Proposal for amendment to the 06 series of amendments to UN Regulation No. 107 (M₂ and M₃)

This document is an improved version of ECE/TRANS/WP.29/GRSG/2013/17, according to the decision of GRSG (see paragraph 18. of the report, No. ECE/TRANS/WP.29/GRSG/83), and it supersedes the above document. The modifications to the current text of the Regulation are marked in bold characters.

"Figure 26 Roof escape hatch access (see Annex 3, paragraph 7.7.4.1.)

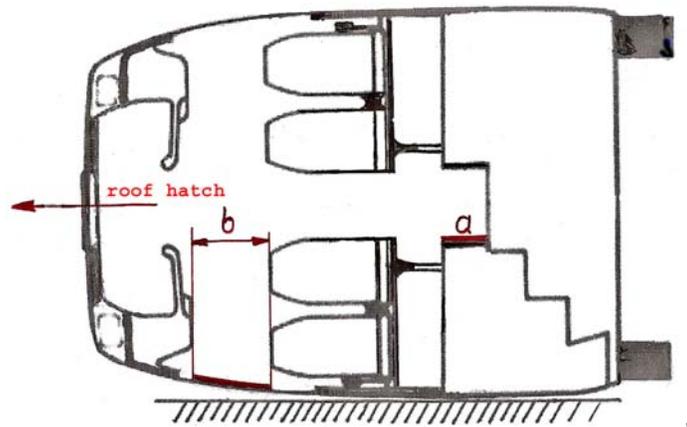
"7.7.4.1. Access to escape hatches, **when the vehicle is lying on either side**

Free motion of the passengers shall be assured along the internal wall of the vehicle to reach the roof hatches. This requirement is met if at least one of the following two requirements is fulfilled (see Figure 26 in Annex 4):

7.7.4.1.1. **There is a sunken gangway having a minimum vertical distance "a" between the gangway surface and the floor of the seating area of [150] mm, or**

7.7.4.1.2. **There is a free height "b" of not less than [400] mm measured from the highest point of each seatback."**

Annex 4, Figure 26, replace the existing figure as follows:

Sketch

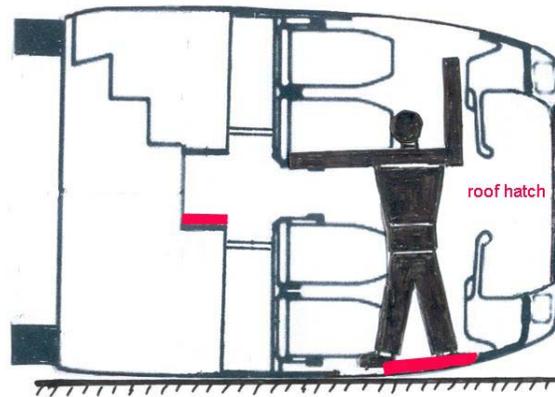
- The sketch below shows two, almost horizontal surfaces for the passenger's motion ("a" in the gangway and "b" on the side walls)
- The gangway can not be used automatically, if there is no horizontal surface, on which the passengers can place their feet and move. Sunken gangway is needed.
- Better way is the horizontal "b" surface on the side wall.
- Some photos from real accidents help to imagine this situation, the escape or rescue of the passengers.
- The situation could be worse, if passengers, using seat belt are hanging on the belt, or without belt they fell onto each other
